## SERVICE LETTER 00022

**Subject:** Short WD-01214-L/R-1 Flaperon Torque Tubes

**Affected Models:** ELSA RV-12iS Finish Kits shipped between March, 2018 and October 12, 2020

**Required Action:** Affected aircraft should install spacer washer

**FIGURE 1: WD-01214-L/R-1 SHOULD MEASURE .875 IN.**

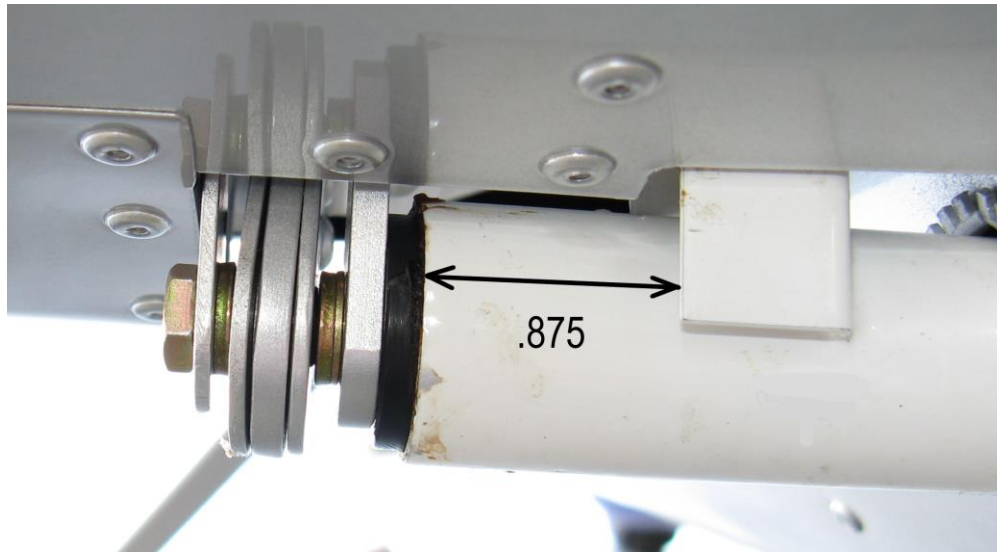
Builder feedback indicated several WD-01214-L/R-1 Flaperon Torque Tubes were fabricated using tubes with insufficient length which resulted in reduced engagement between the torque tube and the A-1211 Pivot Guide. Complying with this service letter adds a spacer to reestablish correct torque tube to pivot guide engagement.

Step 1: Compare WD-01214-L-1 and WD-01214-R-1 torque tubes to the dimension shown in Figure 1. If the measurement is 0.75 in. [19 mm] instead of the 0.875 in. [22 mm] dimension shown, WASHER-00022 should be installed.

**FIGURE 2: INSTALL WASHER-00022**

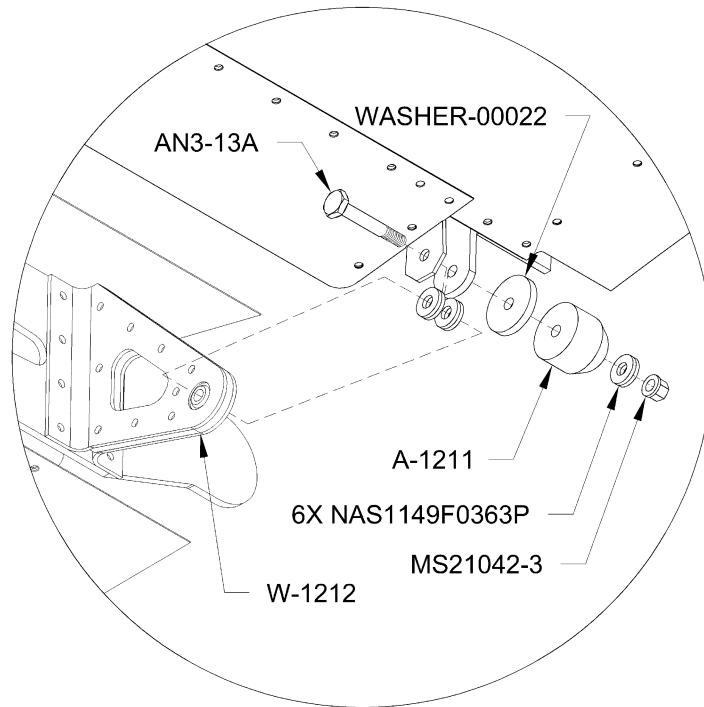
Step 4: Install the AN3-13A bolt, washers, WASHER-00022, A-01211 Pivot Guide, and remaining hardware shown in Figure 2. Torque the MS21042-3 nut to 25 in-lbs.
